BRIDGE SCOUR REPORT

COUNTY: BUNCOMBE BRIDGE: 203 ROUTE: SR 2416 STREAM CROSSED: BEE TREE CR

# BRIDGE SCOUR EVALUATION ASSESSMENT AND DATA SUMMARY REPORT

**Unknown Foundation Determination**  
**Substructure Report**  
**Buncombe 100203**  
**Warren Wilson College Rd. over Bee Tree Creek**

PLAN VIEW AT END BENT 2

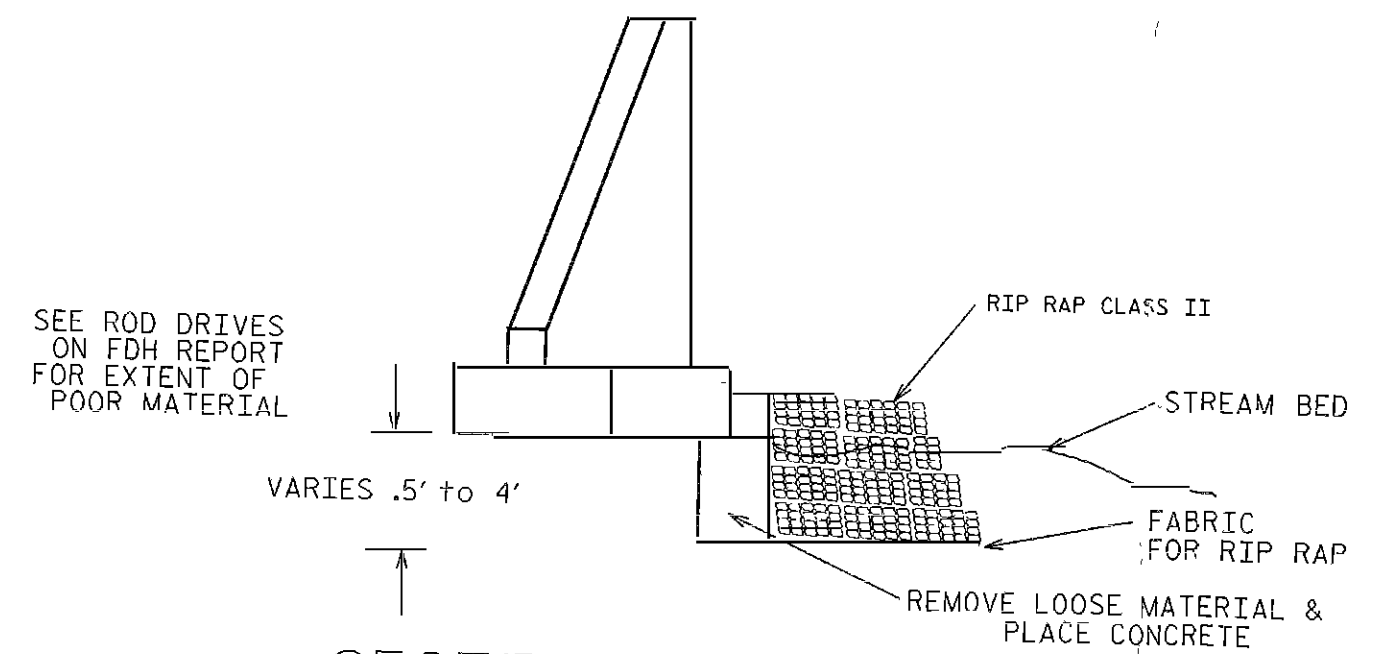
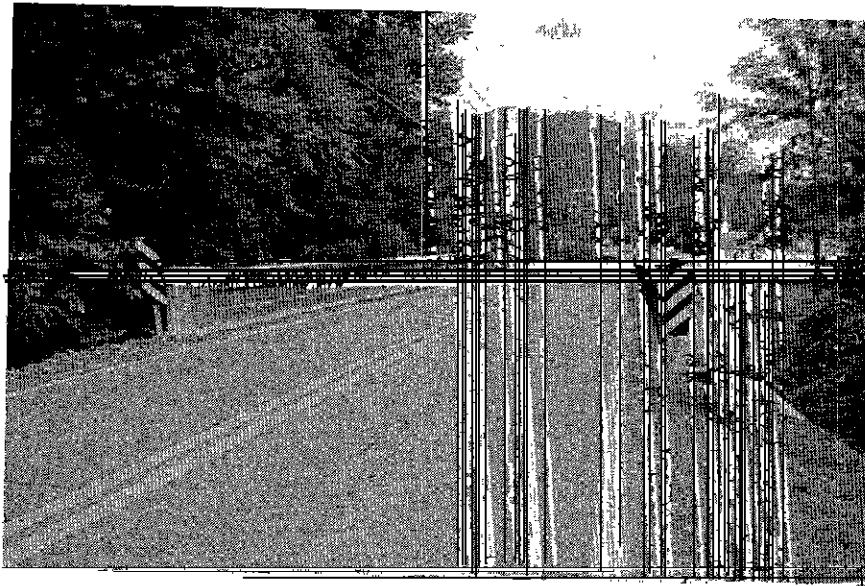
SUMMARY OF PLAN: PLACE CONCRETE & CLASS II RIP RAP @ EB2 TO REPAIR SCOUR SEE ATTACHED PLAN

PLACE CONCRETE & CLASS II RIP RAP @ EB2 TO REPAIR SCOUR. SEE ATTACHED PLAN.

- PLAN NOTES:**
1. FOR CLASS II RIP RAP TYPE SEE NCDOT STANDARD SPECIFICATIONS
  2. OBTAIN PERMITS BEFORE CONSTRUCTION.
  3. CONTACT SCOUR ENGINEER IN HYDRAULICS UNIT FOR PRE- CONSTRUCTION MEETING BEFORE CONSTRUCTION BEGINS.

**EB2**

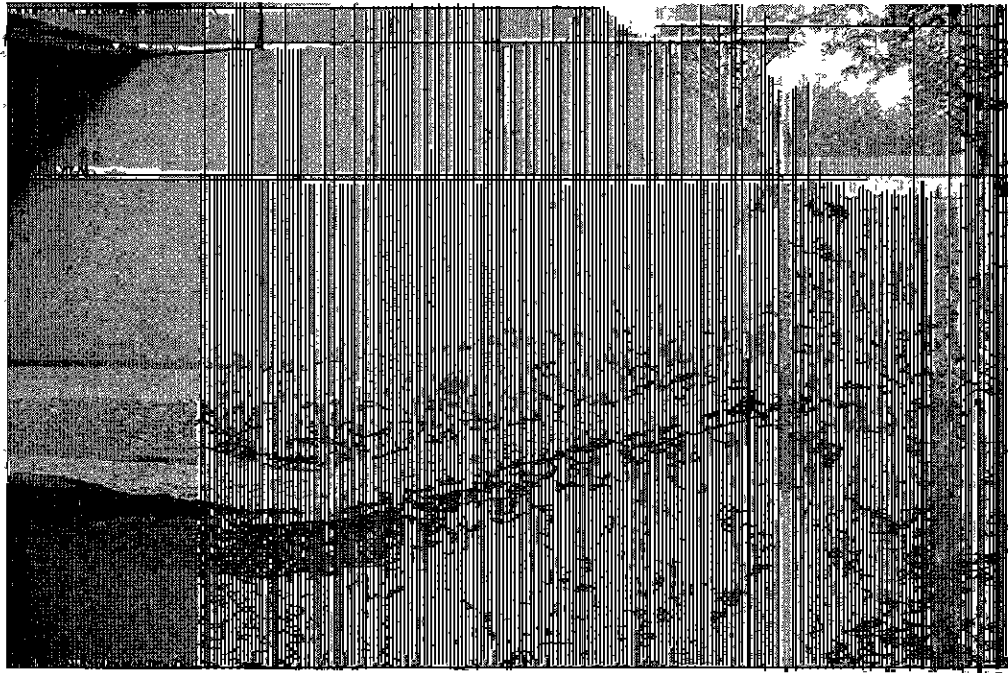
**Scouring has occurred along EB2.**
